Foundation for
Cross-Connection
Control and
Hydraulic Research

Subject: Revision - Evaluation Policy 07-001-R1
Backpressure and Backsiphonage Test

Evaluation Policy 07-001-R1
Backpressure/Backsiphonage Test
07-001 Issued 23 May 2007 (Revision R1 issued 29 August 2007)

Standard
for
Reduced Pressure Principle Assemblies (Section 10.2.2)

*Backsiphonage/Backpressure Test System
Diagrammatic sketch showing location of system components*

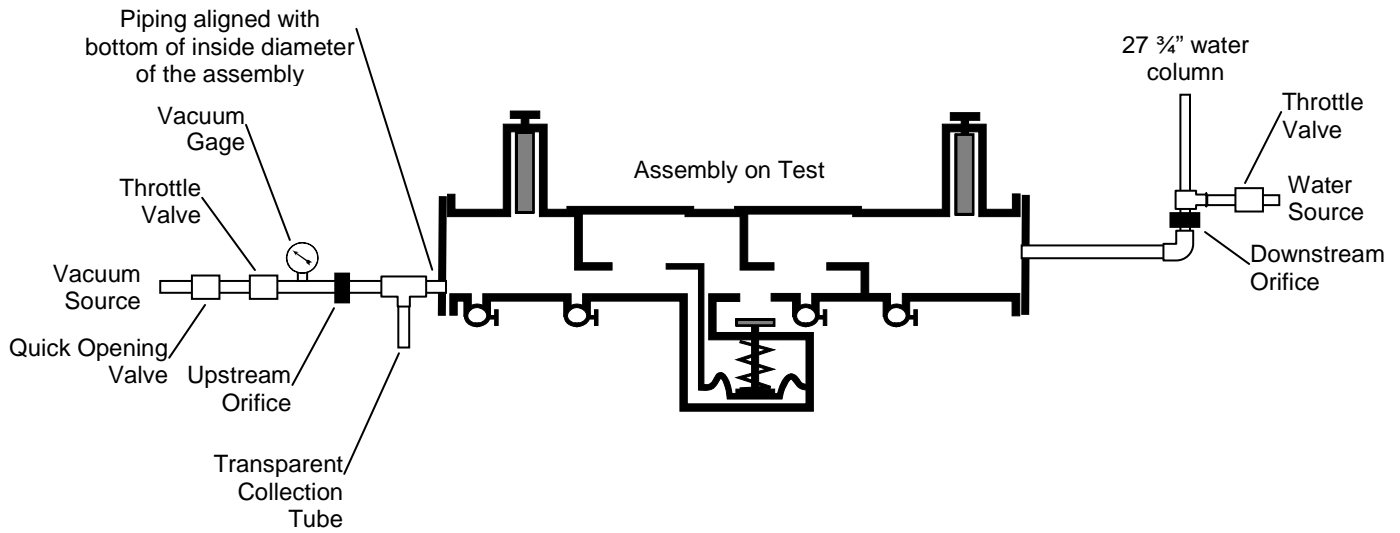
The test below replaces the existing Section 10.2.2.3.8

- Procedure Step ‘a’: Remove the moving member (i.e., poppet or clapper) from the No. 1 and the No. 2 check valves shall be held in the fully open position. Maintain the No. 1 and No. 2 shutoff valves in the fully open position.
 - *Removal of the moving member is consistent with other tests in the Standard.*
- Diagrammatic sketch: Clarification of piping arrangement on upstream side of assembly. Removed the moving members (i.e., poppet or clapper) from the assembly illustration.

- a. Remove the moving members (i.e., poppet or clapper) from the No. 1 and the No. 2 check valves. Maintain the No. 1 and No. 2 shutoff valves in the fully open position.
- b. Install upstream and downstream of the assembly under test, orifices equivalent to the Table below. Orifices shall comply with ASME/ANSI MFC-14M-2003¹ and the downstream orifice shall be located a minimum of five (5) pipe diameters from the No. 2 shutoff valve. The resulting flow of water through the downstream orifice shall be normal to the pipeline.
- c. The assembly shall be subjected to a downstream condition of 1 psi (6.89 KPa).
- d. With the backpressure established as in step "c" above, the assembly shall then be subjected to an upstream condition of 25 inches of mercury vacuum (16.89 KPa absolute).

- e. The vacuum pressure is to be slowly imposed (20 seconds \pm 5 seconds) and maintained for five (5) minutes. Any amount of water collecting in the upstream transparent tube shall be cause for rejection.
- f. The 25 inches of mercury vacuum (16.89 KPa absolute) is to be shock applied (by means of a quick opening valve) for five (5) cycles and any amount of water collecting in the upstream transparent tube shall be cause for rejection.
- g. The assembly shall be inspected for any damage due to the above vacuum tests. Any damage or permanent deformation shall be cause for rejection.
- h. If a drain funnel is provided, tests *e* through *f* shall be repeated with the manufacturer's drain funnel attached to the assembly. Evidence of any amount of water collecting in the upstream transparent tube shall be cause for rejection.

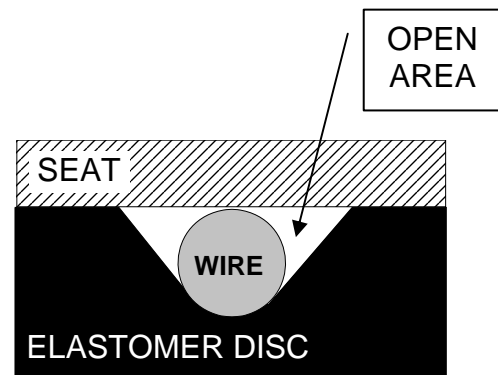
The Staff concluded that the proposed air flow rates of the original draft protocol could be reduced, and still maintain the intent of the test. When performing the test with fouling wires, the air flow would pass through the open area created by the fouling wire embedding in the elastomer disc. (*see illustration at right*) Since the first check valve of the RP has a loading 5-10 times greater than the second check valve, the amount of embedding is significantly greater in the first check valve. Since the fouling wire in the second check valve may not embed as far, this produces a larger open area.

The theoretical open area around the fouling wire in the first check valve was calculated and found to be approximately the same effective diameter as the next smaller fouling wire size contained in Table 10-6 of the 9th Edition. So the size of the upstream orifice (for backsiphonage) contained in the new protocol will correspond with the diameter of the next smaller sized fouling wire. The air flow rates produced by the orifice of the next smaller diameter compare relatively close to the air flow rates recommended to the Staff.
